PRELIMINARY APPROVAL
DEVELOPMENT PLAN

PROPOSED LAUNDROMAT
331 EAST OAK STREET (40203)
REVISED DETAILED DISTRICT DEVELOPMENT PLAN
O ld Case No. 09-013-81/New Case No. 14DEVPLAN1009

14DEVPLAN1009

TYPICAL PARKING SPACE DIMENSIONS DETAIL

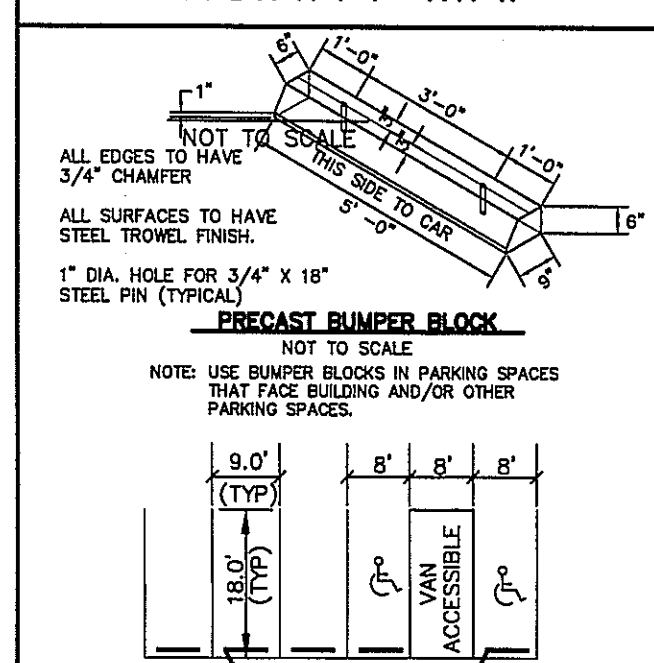
CONDITIONS: The neutral zone beside
the ADA parking must be a full 8x19
flush to pavement, with ramp provided.
BY: *James Hallett*
DATE: 3-12-14
LOUISVILLE/JEFFERSON COUNTY
METRO PUBLIC WORKS
